UNITED STATES PATENT AND TRADEMARK OFFICE

APPLICATION NO.	FILING DATE	FIRST NAMED INVENTOR	ATTORNEY DOCKET NO.	CONFIRMATION NO.
10/670,045	09/24/2003	James R. Hawkinson	165.001US01	5025

Office Action Summary

DETAILED ACTION

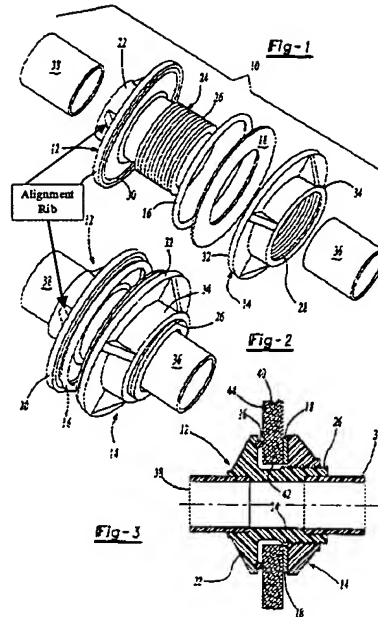
In regards to claim 9, Hawkins discloses an alignment rib (see Figures 1 and 2 below) disposed on the coupling between the flange and the second end.
